# Access Compliance Report

## Public Rights-of-Way

Intersection ID: 8739	Main Street: N_TRYON_ST	Cross Street: W_EASTWAY_DR	Location: SE
ADA ID: B3FAFBF459DF	Ramp Type: Perp	Initial Pass/Fail: Fail	Overall Compliance: No
Severity Score: 12.5			
Codes/Mitigation Info/Possible Solution		Field Measurements/Component Compliance

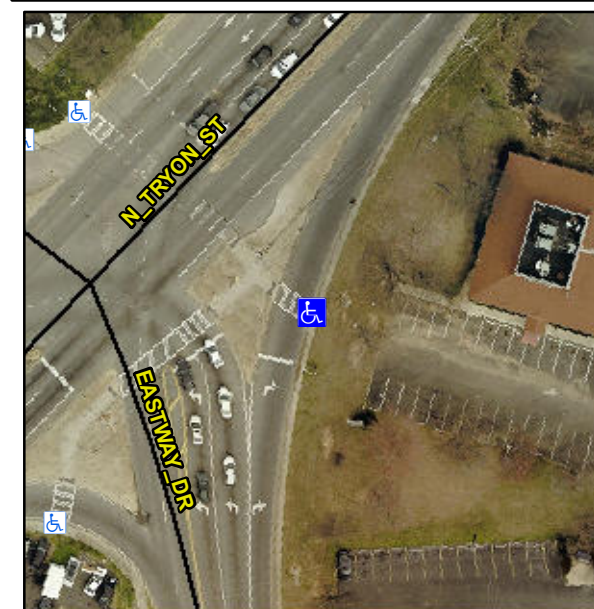
**Not Found, R304.2.2**

Compliance	Description	Data	Compliance	Description	Data
N/A	Ramp Length (in)	48.5	No	Ramp Slope (%)	8.8
Yes	Ramp Width (in)	48.0	Yes	Ramp XSlope (%)	0.7
N/A	Flare Type LT	N/A	N/A	Flare Type RT	N/A
N/A	Flare Slope LT (%)	N/A	N/A	Flare Slope RT (%)	N/A
N/A	Flare Traversable LT?	N/A	N/A	Flare Traversable RT?	N/A
N/A	Landing Length (in)	N/A	N/A	DWS Provided?	N/A
N/A	Landing Width (in)	N/A	N/A	DWS Contrast?	N/A
N/A	Landing Slope (%)	N/A	N/A	DWS Length (in)	N/A
N/A	Landing X Slope (%)	N/A	N/A	DWS Full Width?	N/A
N/A	Landing Curb? (Y/N)	N/A	N/A	DWS Offset (in)	N/A
N/A	Shared Landing?	N/A			
N/A	Gutter Ponding?	N/A	N/A	Gutter Slope (%)	N/A
N/A	Gutter Lip Ht (in)	N/A	N/A	Gutter X Slope (%)	N/A
N/A	Painted X Walk1?	Yes	N/A	Painted X Walk2?	N/A
	X Walk 1 Direction	To NW		X Walk 2 Direction	N/A
N/A	X Walk 1 Width (in)	110.0	N/A	X Walk 2 Width (in)	N/A
	X Walk 1 Slope (%)	5.5		X Walk 2 Slope (%)	N/A
	X Walk 1 X Slope (%)	0.5		X Walk 2 X Slope (%)	N/A

**Remove & Replace Entire Ramp.**
